Subject: Portland Wharf Storage Basin
Minor Project Modification
IOAP Project No. L_OR_MF_019_S_13_B_A_8
DOJ Case No. 90-5-1-1-08254

MSD is requesting approval of a proposed minor project modification to the Portland Wharf Storage Basin project (IOAP Project No. L_OR_MF_019_S_13_B_A_8). This request is part of the ongoing adaptive management review of the approved Integrated Overflow Abatement Plan (IOAP) dated May 2014.

2015 Project Modification Request

Ohio River
Portland Wharf Storage Basin

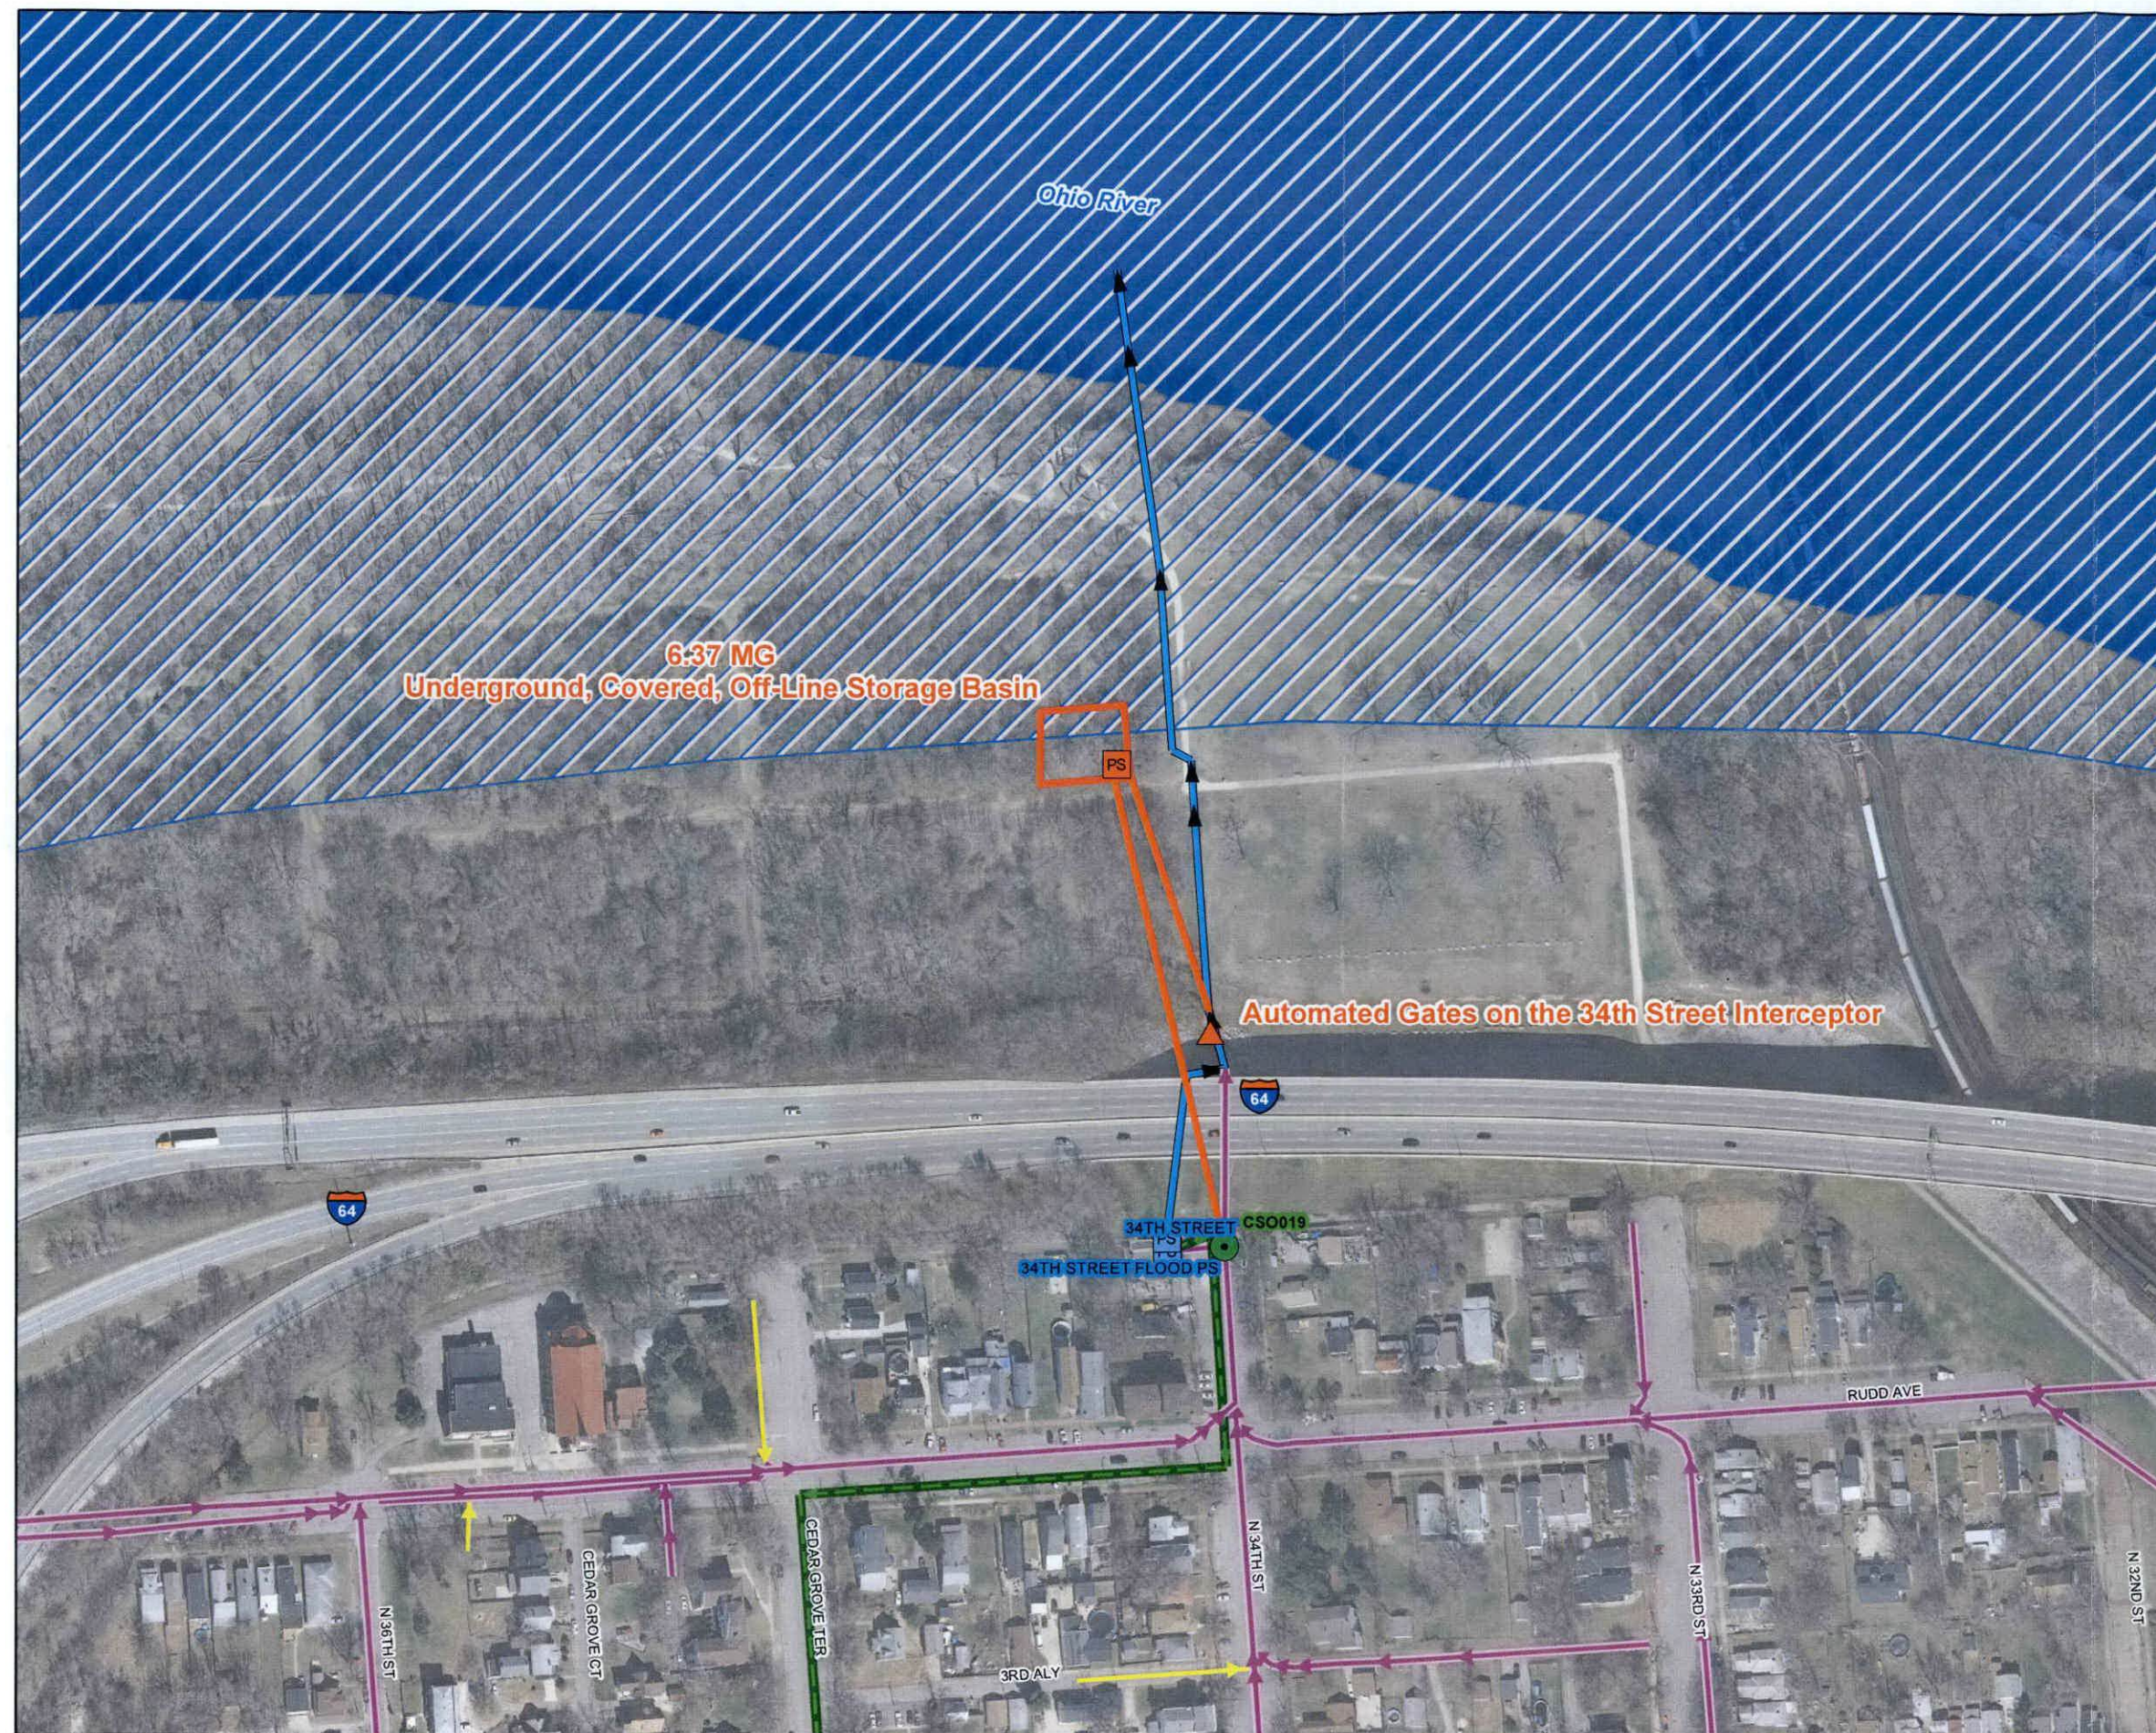
This project modification request includes increasing the Portland Wharf Storage Basin size from 6.37 MG to 6.7 MG. The level of control is proposed to remain at 8 overflows per year in the typical year. The larger size

does not reduce CSO occurrences significantly, but does provided a reduced residual AAOV. No change in project completion date is proposed.

Project Description: This project includes a 6.7 MG underground covered concrete storage basin, with 1.8 MG of in-line storage from CSO019 to reduce overflows to 8 overflows per year in a typical year. The facility will require a 6.37 MGD pump station to return the stored flow back to the interceptor.
